Access Compliance Report

Public Rights-of-Way

Intersection ID: 13988	Main Street: E_5TH_ST	Cross Street: LAMAR_AV	Location: NE
ADA ID: FBD2FF344426	Ramp Type: PerpDiag	Initial Pass/Fail: Fail	Overall Compliance: No
Severity Score: 8.75			
Codes/Mitigation Info/Possible Solution		Field Measurements/Component Compliance

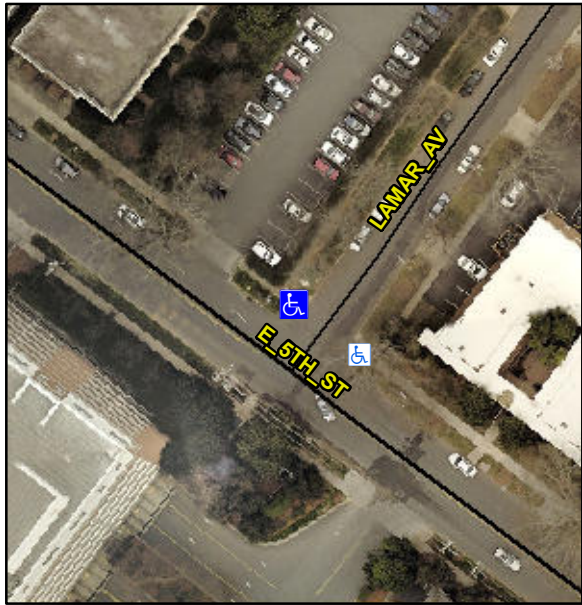
Possible Solutions:		Compliance		Description	Data	Compliance	Description	Data
	Remove & Replace Curb Ramp With Two New Directional Ramps or Equivalent.		N/A	Ramp Length (in)	86.0	Yes	Ramp Slope (%)	5.2	
			No	Ramp Width (in)	46.0	Yes	Ramp XSlope (%)	0.8	
			N/A	Flare Type LT	N/A	N/A	Flare Type RT	N/A	
			N/A	Flare Slope LT (%)	N/A	N/A	Flare Slope RT (%)	N/A	
			N/A	Flare Traversable LT?	N/A	N/A	Flare Traversable RT?	N/A	
			N/A	Landing Length (in)	N/A	N/A	DWS Provided?	N/A	
			N/A	Landing Width (in)	N/A	N/A	DWS Contrast?	N/A	
			N/A	Landing Slope (%)	N/A	N/A	DWS Length (in)	N/A	
			N/A	Landing X Slope (%)	N/A	N/A	DWS Full Width?	N/A	
Surveyor Notes:		N/A	N/A	Landing Curb? (Y/N)	N/A	N/A	DWS Offset (in)	N/A	
PROW/ADA:		Not Found, R304.5.1	N/A	Shared Landing?	N/A	N/A			
			N/A	Gutter Ponding?	N/A	N/A	Gutter Slope (%)	N/A	
			N/A	Gutter Lip Ht (in)	0.5	N/A	Gutter X Slope (%)	N/A	
			N/A	Painted X Walk1?	No	N/A	Painted X Walk2?	No

X Walk 1 Direction	To SW		X Walk 2 Direction	To SE	
			N/A	X Walk 1 Width (in)	N/A	N/A	X Walk 2 Width (in)	N/A	
				X Walk 1 Slope (%)	4.0		X Walk 2 Slope (%)	4.4	
				X Walk 1 X Slope (%)	2.0		X Walk 2 X Slope (%)	3.7	
			N/A	Ramp inside XWalk1?	N/A	N/A	Ramp inside XWalk2?	N/A	
				Road Slope (%)	1.8	N/A	Clear Space?	N/A	
				Road X Slope (%)	4.4	N/A	Clear Space to XWalk (in)	N/A	
			N/A	Any Obstructions?	N/A	N/A	Storm Grate/Utility Hazard?	N/A	
				Obstruction Type			Storm Grate/Utility Type		
					N/A			N/A	
						Yes	Surface Condition? (G/P)	Good	
Total Cost:		\$	3200.00
